Lake Crabtree Park Improvements Bid Addendum #2

Date: 08/28/2026
Wake County RFB #: 26-078
WR Project #: 22-0024-007

Notice to All Bidders:

UTILITY PLAN -
EDUCATION CENTER

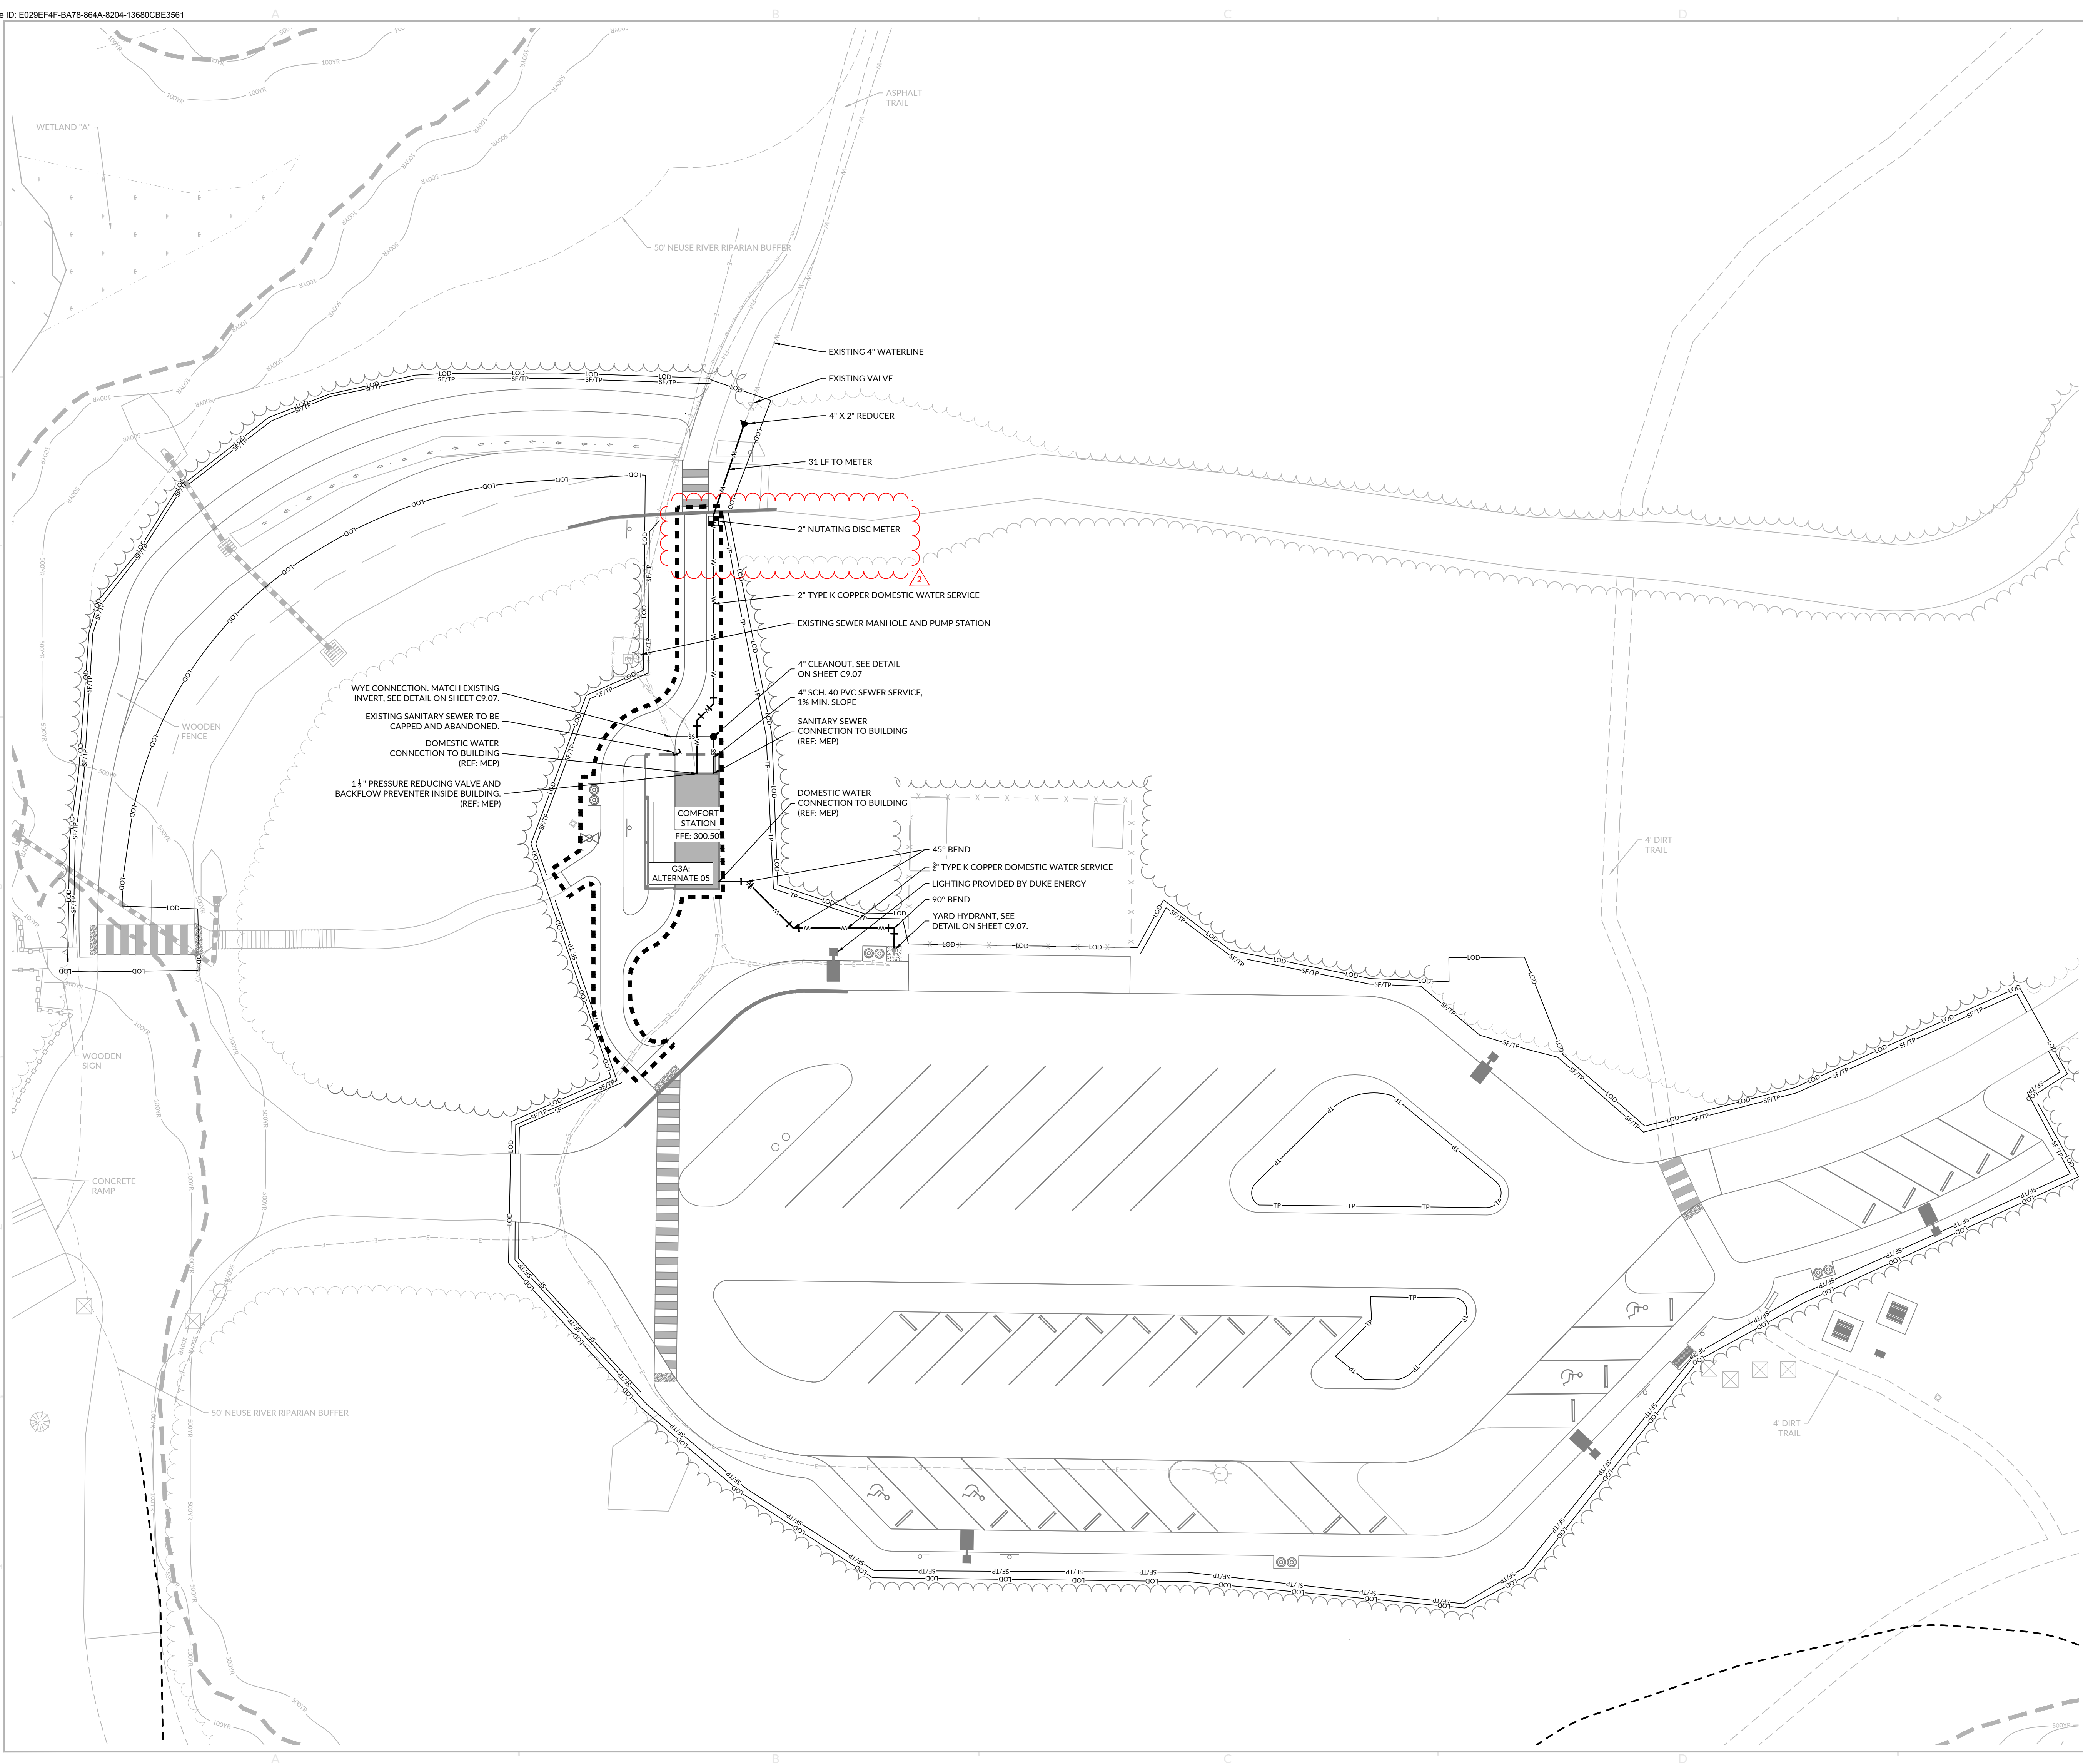
A. **The pressure reducing valve has been removed from sheet C4.31.**
14. Q. On sheet 4.21, it says 2" backflow with 1.5" pressure reducing valve after backflow. On the plumbing drawing P4.21, it shows the 1.5" pressure reducing valve inside the bldg right

1. C4.21 - UTILITY PLAN - EDUCATION CENTER
 - a. Lateral saddle connection detail callout updated.
2. C4.31 - UTILITY PLAN - COMFORT STATION
 - a. The pressure reducing valve has been removed.

- after it enters. They only need one so should verify which one they want to remove.
- A. The pressure reducing valve is to remain as shown on sheet C4.21.**
15. Q. Multiple sheets refer to details on 9.07 that are not there. They are Sewer cleanout detail, Wye connection to existing detail, and 2" backflow with pressure reducing valve detail."
- A. The details have been added to sheet C9.07.**
16. Q. Please also confirm whether subcontractor proposals should show a standalone. EWF1 total, a net add/deduct over WF1, or both
- A. Show as a net add/deduct**
17. Q. Will there be another subcontractor site visit prior to bid date?
- A. Lake Crabtree is a Public Park, and contractors may visit during operating hours.**

UTILITY DETAILS

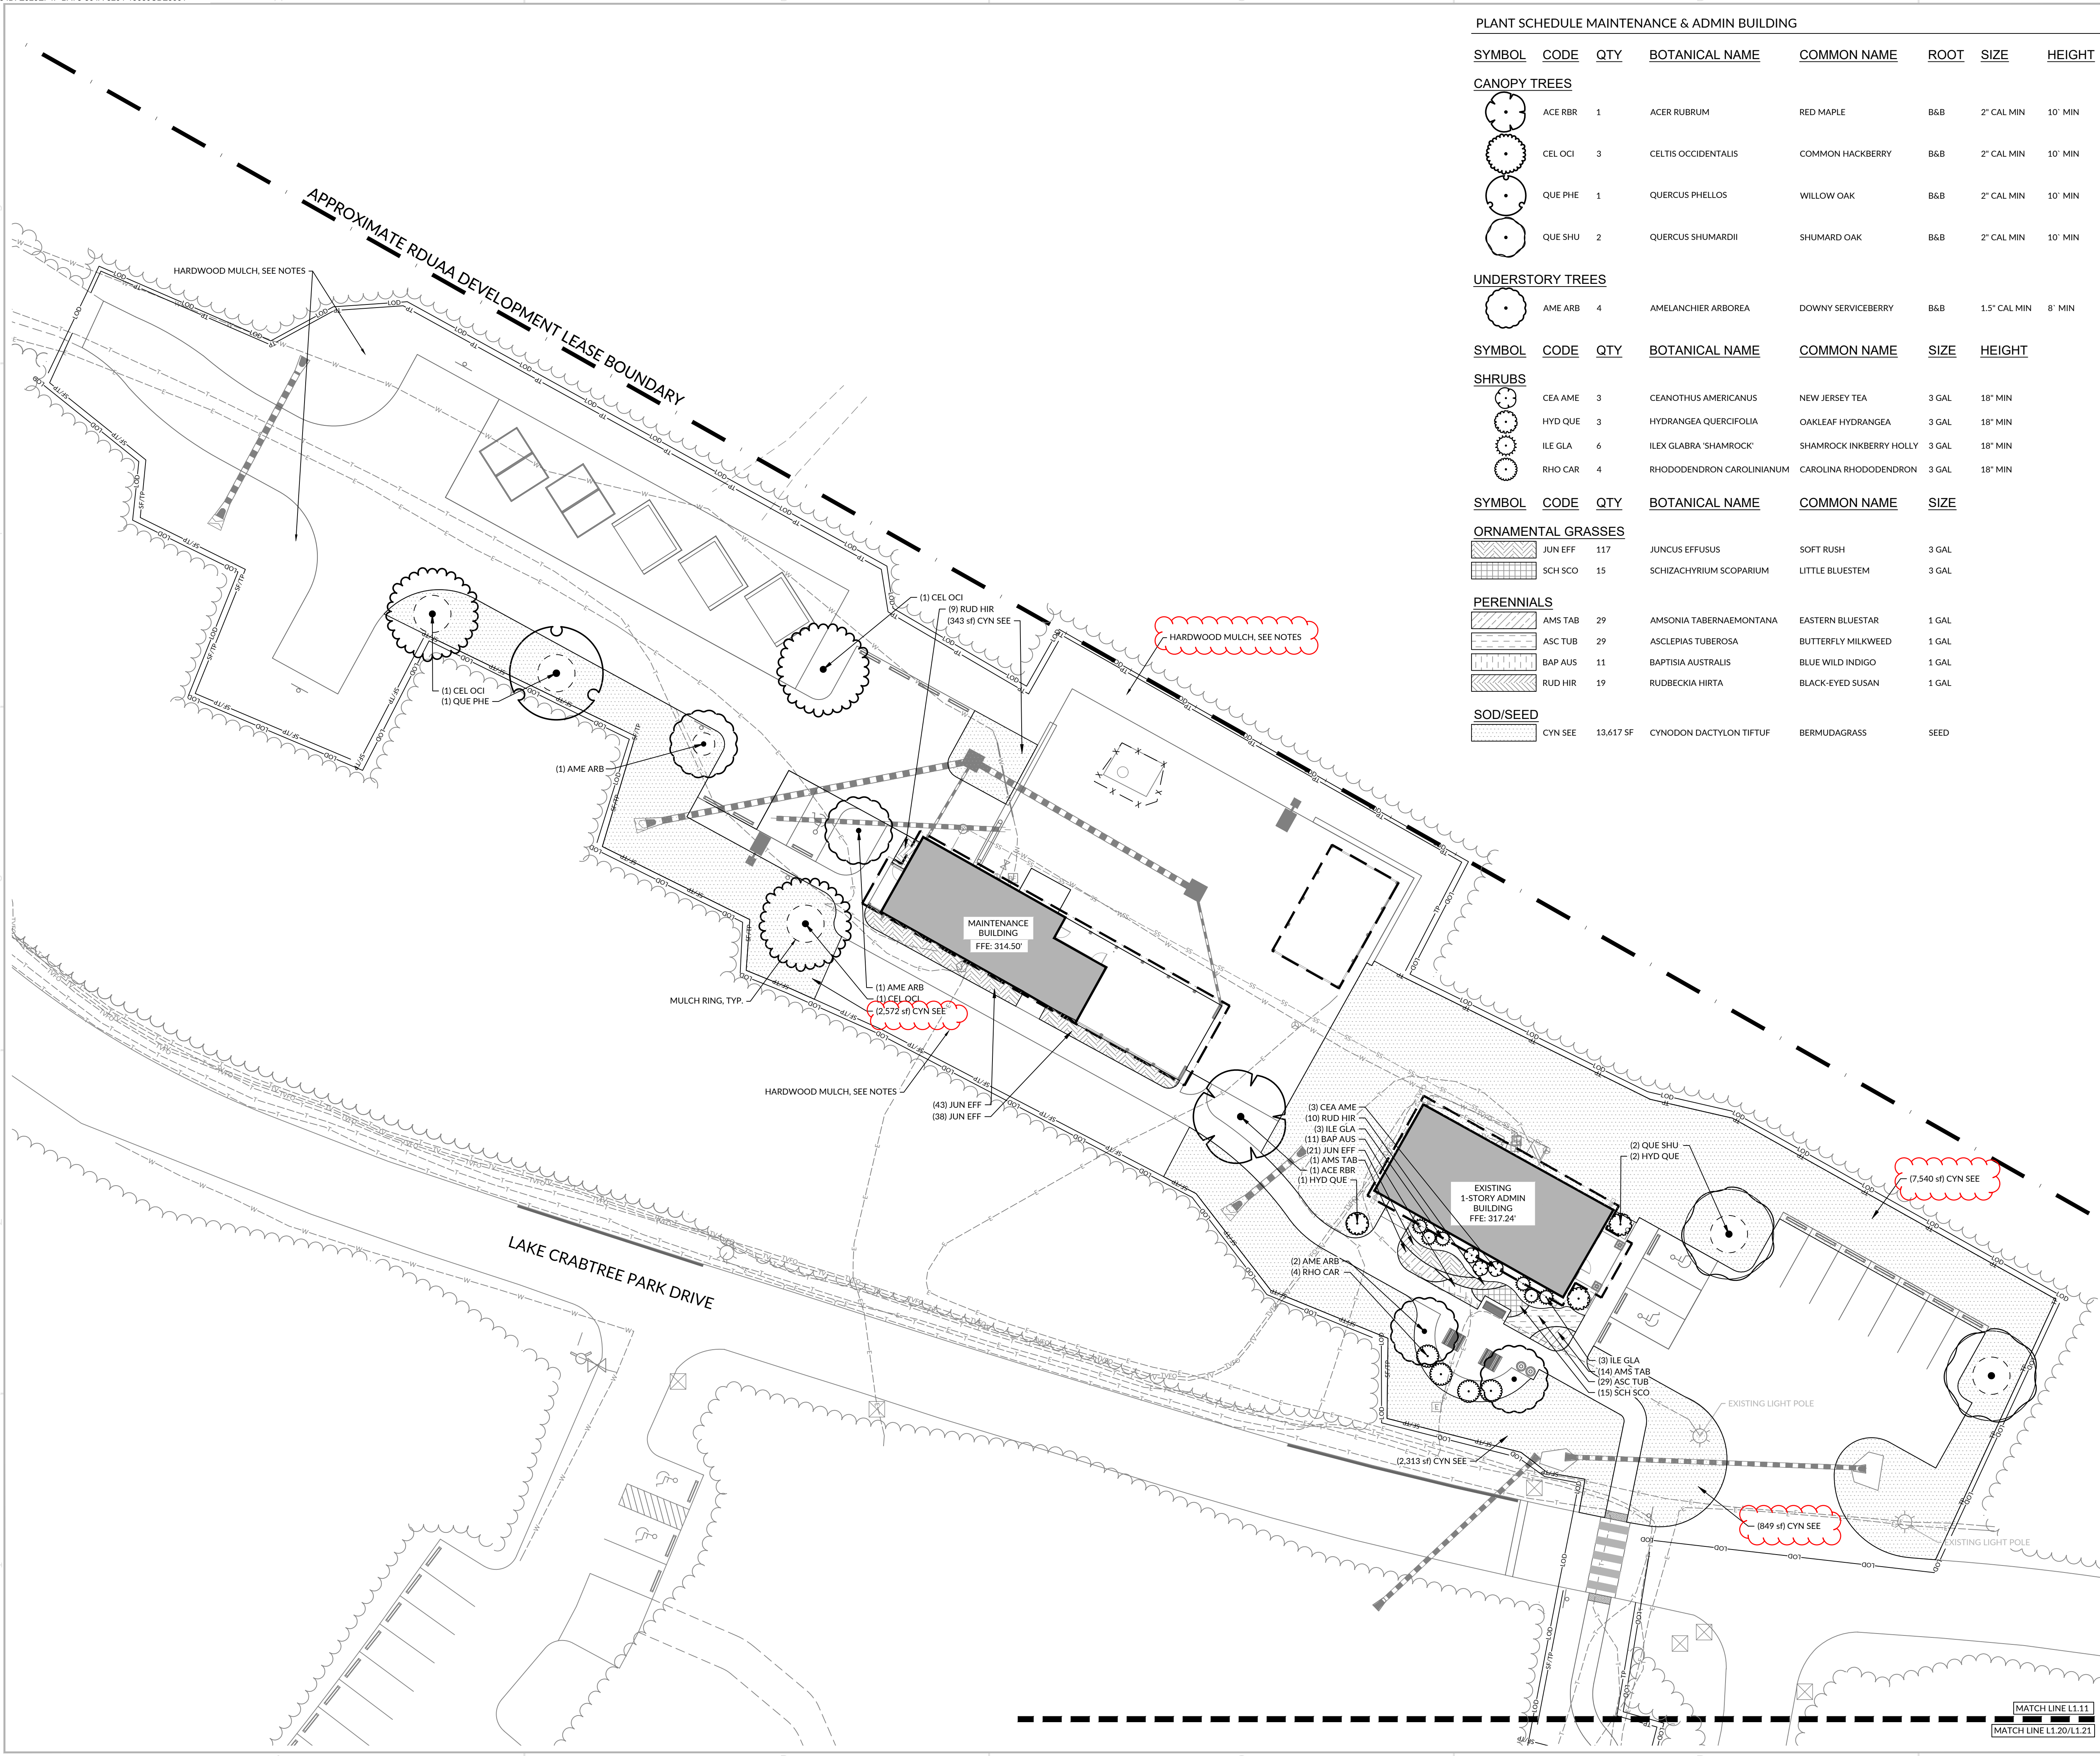
3. C9.07 - UTILITY DETAILS
 - a. Details added
4. L1.11, L1.20, L1.20, L1.21, L1.31 - LANDSCAPE PLANS
 - a. Seeded and mulched areas have been clearly defined on updated landscape plans.
